Pre-Bid Queries Against Adani Tender No.: AEML/MTB/2019-20/03

Turnkey Tender for Supply and Installation of 220kV cable system from AEML's 220kV Chembur EHV station to LILO tower of MSETCL Trombay – Nerul 220kV transmission line.

TITLE: ELEVATION DRAWING
CABLE TERMINATION TOWER
(MONOPOLE)

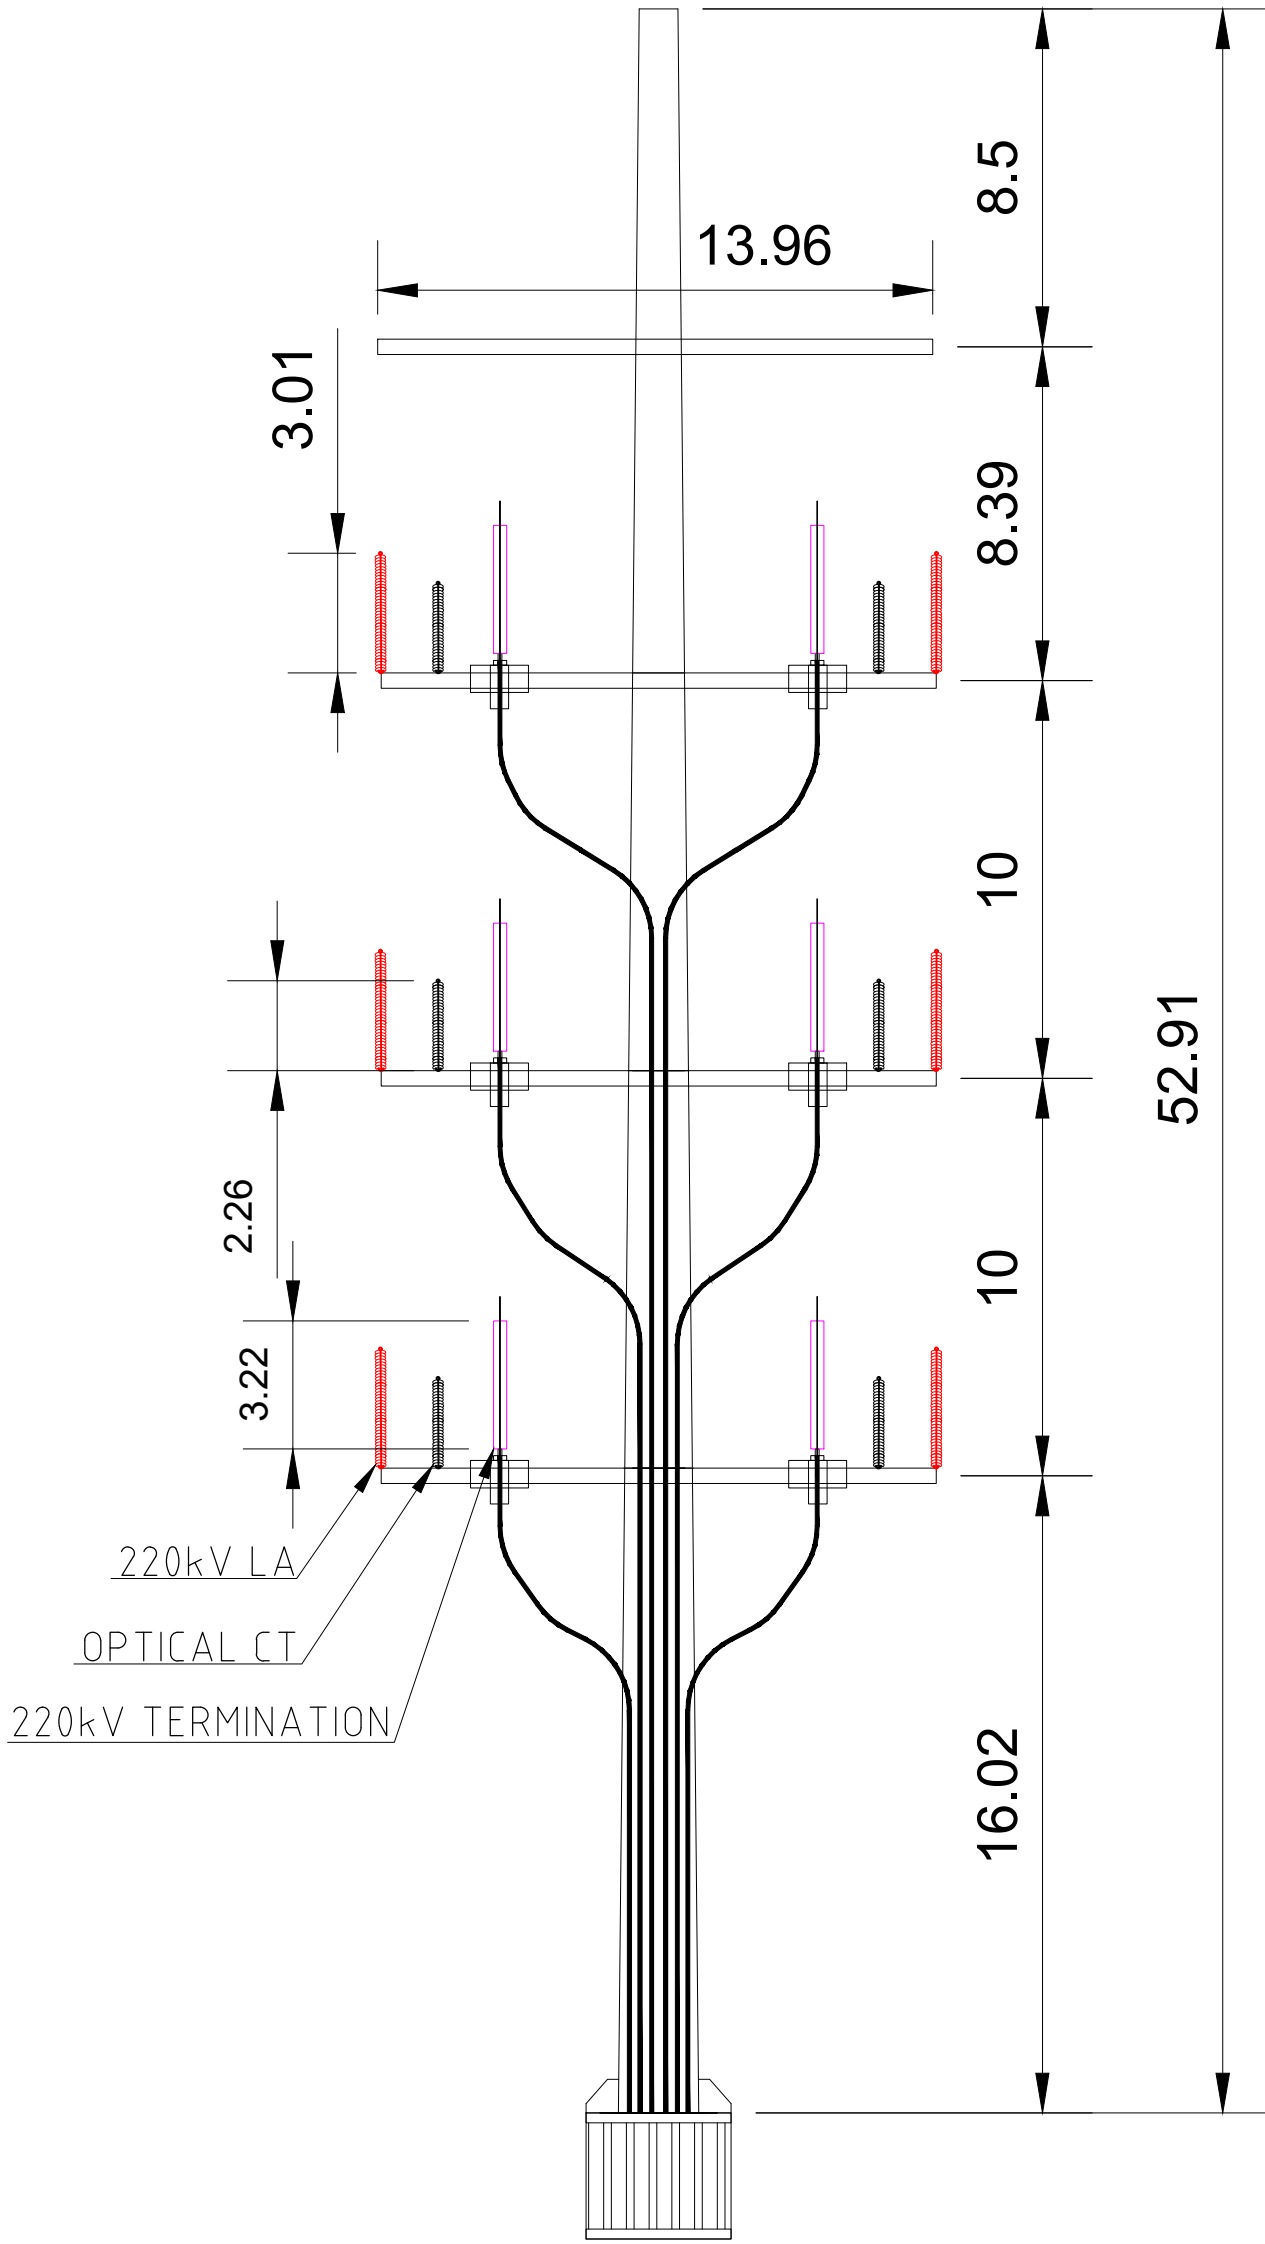
48	ANNEXURE K-TENDER BOQ, S.NO-1 & 2.	UNIT	Request for clarification: Please change the Unit of Quantity from "KM" to " ROUTE KM" and do the necessary ammendment for clarity purpose.	Double ckt for 2.5 kM
49	GENERAL	LILO TOWER DRAWING	Request for clarification: Please provide the LILO Tower (Monopole/Lattice) Drawing for Estimating the quantity of Cable and steel structure to be fixed on the LILO Tower.	plese refer Annexure 6A
50	GENERAL	RESTORATION WORK	Request for clarification: As discussed during the Prebid Meeting, the Restoration Work of Road/Footpath/Inter-locking Tiles is not in Bidder's scope. Also M/s Adani shall pay all the Statutory charges directly to the concerned corporations without any financial implications on the bidder. Please confirm the same.	Please refer Cl. No 6 of Main tender document
51	GENERAL	ROW/ROAD CUTTING PERMISSIONS	Request for clarification: Please confirm that all the ROW/ROAD CUTTING PERMISSIONS is in M/s Adani's Scope.M/s Adani shall pay all the Statutory charges directly to the concerned Departments without any financial implications on the bidder. Please confirm the same.	Please refer Cl. No 6 of Main tender document
